Request for Additional Information (RAI)
NEDE-33083P, Supplement 1, "TRACG Application for ESBWR Stability Analysis"

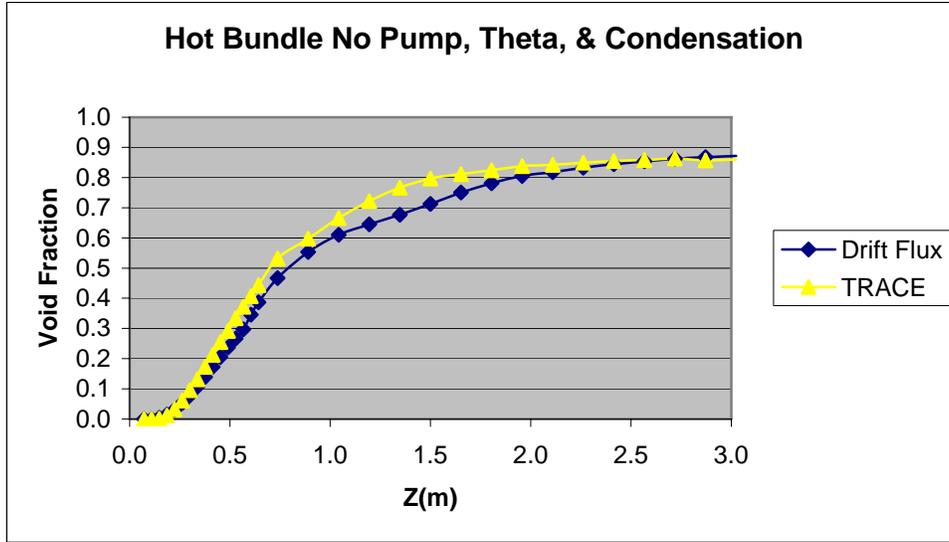
15. As part of the staff's review your interfacial drag models in TRACG, a calculation was performed that predicts void fraction as a function of elevation in the hot bundle. This was performed using TRACE and a standalone drift flux calculation that uses the models in Ref. 1. The staff found that the results were slightly different. This was expected since there are modeling differences between TRACE and the TRACG models in Ref. 1.

TRACG uses the Rouhani-Bowring model² for the energy distribution in subcooled boiling while TRACE uses the Lahey's mechanistic model³. The models are essentially the same, except the TRACE model does not include the pumping factor.

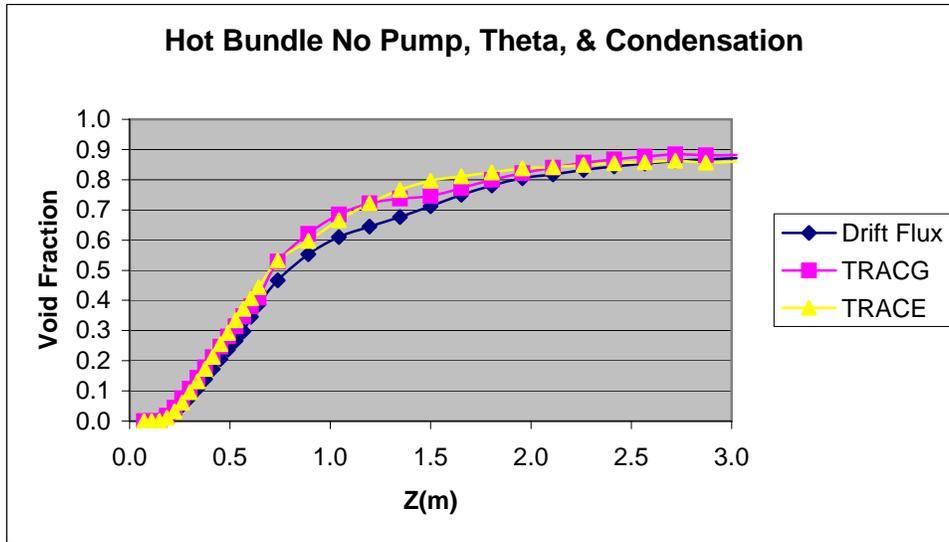
The standalone drift flux model was modified to set the pumping factor to zero, remove the theta factor for modification⁴ of C_o in the subcooled boiling regime, and ignore condensation in the subcooled boiling regime. The cases were re-run and the two results agree quite well.

These void fraction profiles were then compared to the TRACG data in the MS Excel file MFN 05-014 Channel Data.

This also agreed quite well, which was not expected. The staff expected that in the subcooled region the TRACG data would agree with the drift flux model in the prior to the modifications since that model is using the same models in Ref. 1.

Please provide the following so that the staff may understand or resolve the differences:

- a) Confirmation that the pumping factor and theta factor are used in TRACG.
- b) Axial power profile for the ESBWR hot bundle at steady-state.

- c) Location of the grid spacers and the form loss used for the grid spacers and the flow area for the grid spacers.
 - d) Provide a density wave propagation time based on the TRACG results.
